Creative Outerwear Ltd

1 March 2026

Structural Inspection Report

Observation 1: Inconsistencies in the permit drawing. (Production Building)

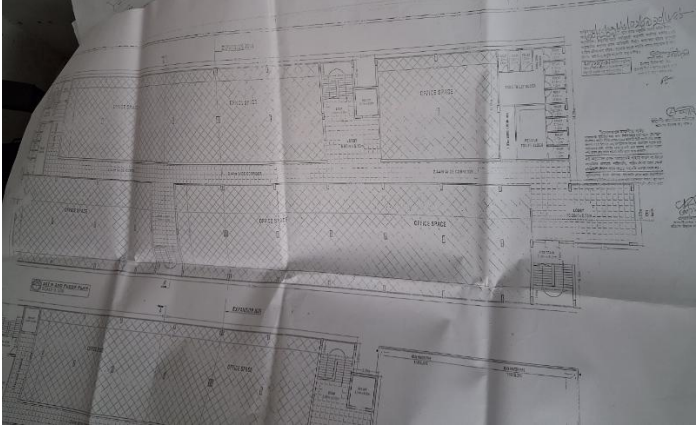
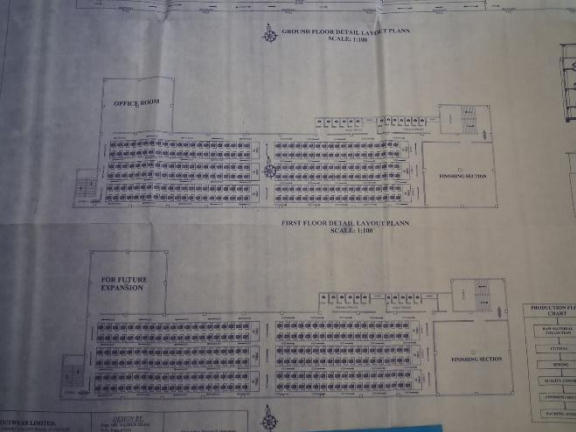
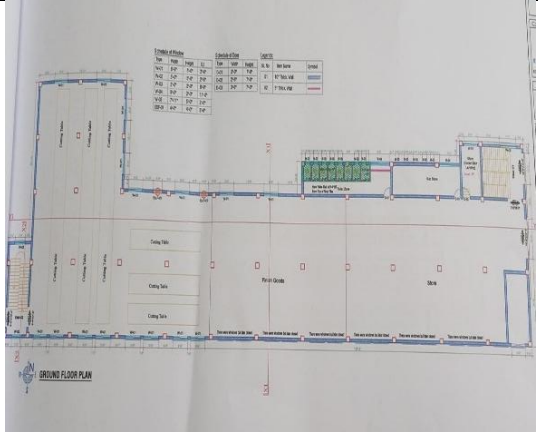
Permit drawing layout plan obtained from the local authority (CDA)	Permit for the proposed 5-storied commercial building

Industrial layout plan from DIFE	As-built layout plan
Description: The building approval/ permit drawing layout plan was provided by the Chittagong Development Authority (CDA) (Local Authority) for the 5-storied commercial building. The layout, area and type of building are not indicative to the as-built construction. The building engineer is required to seek a fresh approval/permit drawing from the concerned local authority and its implementation on the building code determination.

Item No.	Observation	Action Plan	Timeline
1.	Inconsistencies in the permit drawing. (Production Building)	The building engineer is required to seek a fresh approval/permit drawing from the concerned local authority and its implementation on the building code determination.	within 6 months

Observation-4: Discrepancies in the as-built drawings. (Production Building)

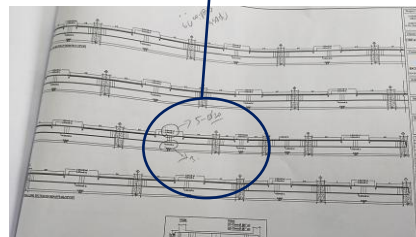
Undocumented floor build-up

Rebar at top found 5 nos instead of 6 nos.

Description: During inspection, undocumented 12 inch (300 mm) floor build-up was found at the toilet zone. Also, 6 inch undocumented floor build-up found at 2nd floor Maintenance room. Moreover, top rebar at typical floor beam was found 5 nos. instead of 6. No stair top slab or beam details found in the structural drawing. The building engineer is required to update the as-built drawings as per actual site condition and submit them to RSC for review.

7.		Carryout suggested remedial works (if required)	within 6 months
8.	Discrepancies in the as-built drawings. (Production Building)	The building engineer is required to update the as-built drawings as per actual site condition and submit them to RSC for review.	within 6 weeks

Observation 11: Lack of design report. (Utility Building)

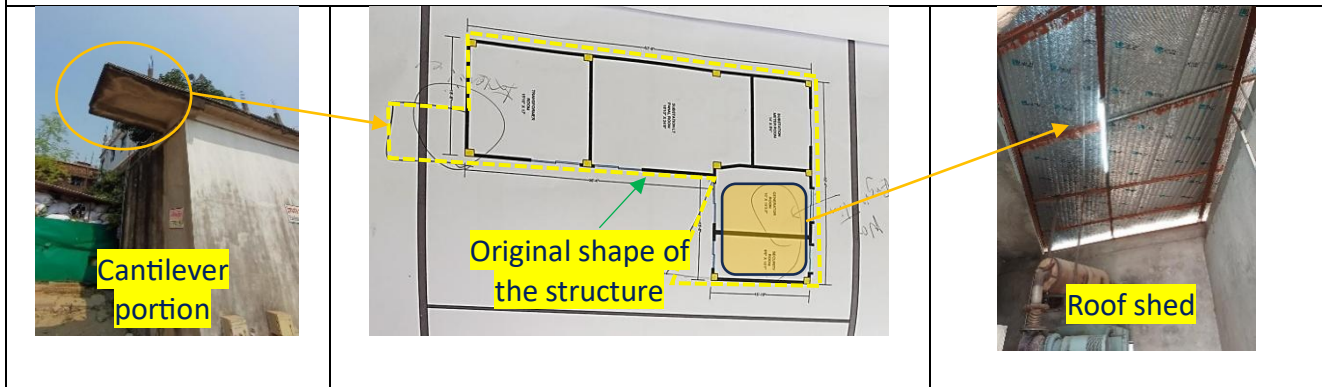
Description: As per BNBC, every building or structure designed shall have its design documents prepared under the provisions of Section 1.9. At the time of inspection, no design report and material test reports were available on-site. Also, lack of lateral stability and poor connection details were found in the roof shed. The building engineer is required to prepare an Engineering Assessment (EA) report as per BNBC and submit to RSC for review.

15.	Lack of design report. (Utility Building)	The building engineer is required to prepare an Engineering Assessment (EA) report as per BNBC and submit to RSC for review.	within 6 weeks
